Re: Proposed Watermark Coal Mine – Review of Shenhua Coal Response to PAC Assessment

I have conducted a further review of reported groundwater impacts associated with the Shenhua Watermark Project. This review is subsequent to my report dated 14/08/2014 (MER, 2014a) and specifically addresses the response provided by the proponent Shenhua Watermark Coal P/L (SWC) to the PAC report dated August 2014.

Figure 2: Assessed drawdown for Scenario 3 (from AGE 2014b Figure 2.15)

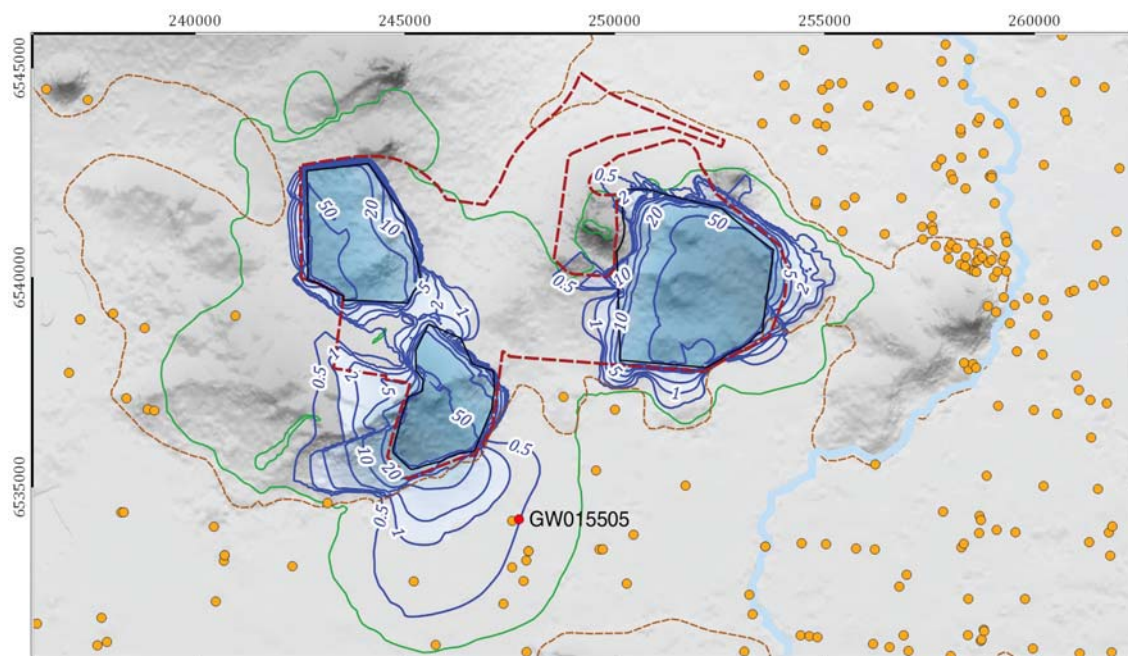
The modelled drawdown of the water table after 30 years for scenario 3 is shown on Figure 2¹³. Drawdown impacts surrounding Eastern pit are generally minimal due to:

- the elevated terrain on which the pit is situated;
- the generally poor water transmitting properties of the rock mass (Permian coal measures);
- and the small penetration of the water table at the deepest part of the pit relative to water table elevations in the alluvial lands (about 40 m).

Drawdown surrounding Southern pit is more extensive with the 1.0 m contour migrating approximately 1.5 km southward from the pit crest. Drawdown of 0.5 m is predicted to extend to the nearest private pumping bore (GW015505) about 2 km from the pit crest as indicated by the red dot¹⁴ on Figure 2. Drawdown associated with Western pit is relatively minor due to shallower mining below the water table.

After consideration of the additional modelling and the responses to questions put to the proponent in respect of certain attributes of these models, I believe the maximum drawdowns in the water table during and at the completion of mining are best represented by scenario 3 (see Figure 2). Close inspection of these drawdowns shows the impacts are modest in areas close to the mine pits and diminish with increasing distance from the pit crests. A maximum drawdown of 2 m permitted by the Aquifer Interference Policy does not encroach upon any private water supply borehole; drawdown of 0.5 m is likely to extend southward to the nearest private pumping bore (GW015505) about 2 km from the pit crest. These relatively low drawdown impacts are considered to be acceptable and manageable.

Figure 3: Assessed drawdown for Scenario 6 - faults removed from the model

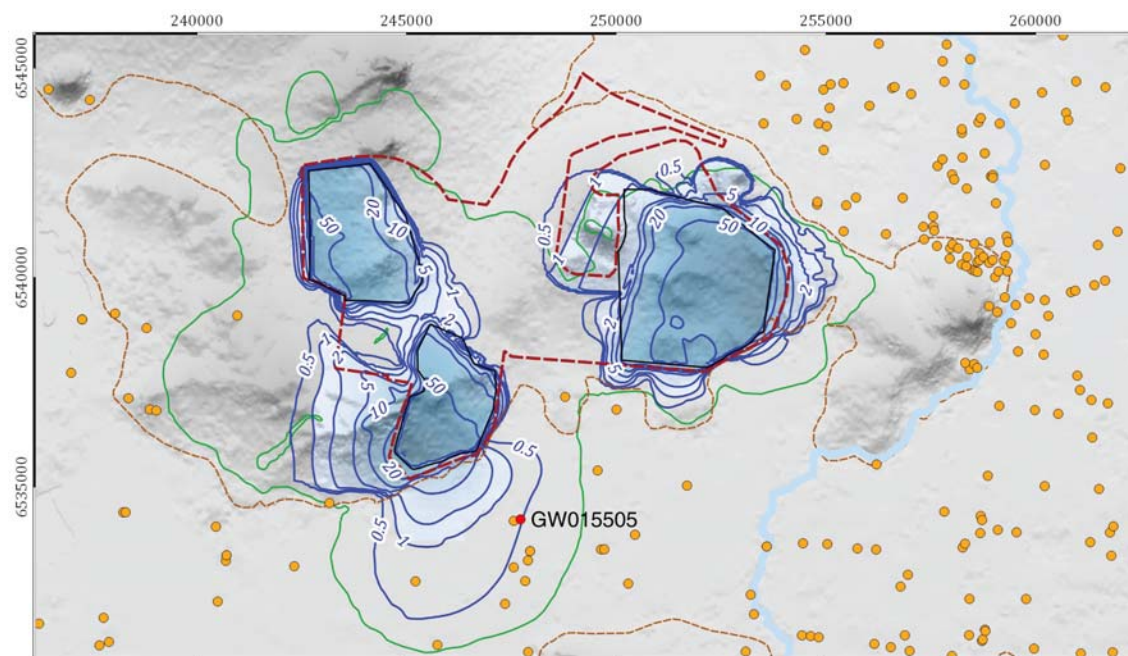
Scenario 3 includes numerous faults that transect the project area and apparently compartmentalise the groundwater flow system¹⁵. Scenario 6 is a variant of scenario 3 which removes the faults and their compartmentalising effect, from the model. The modelled drawdown of the water table after 30 years for scenario 6 is shown on Figure 3 where impacts to the east of Eastern pit remain minimal while drawdowns to the south of Southern pit are slightly more expansive than scenario 3.
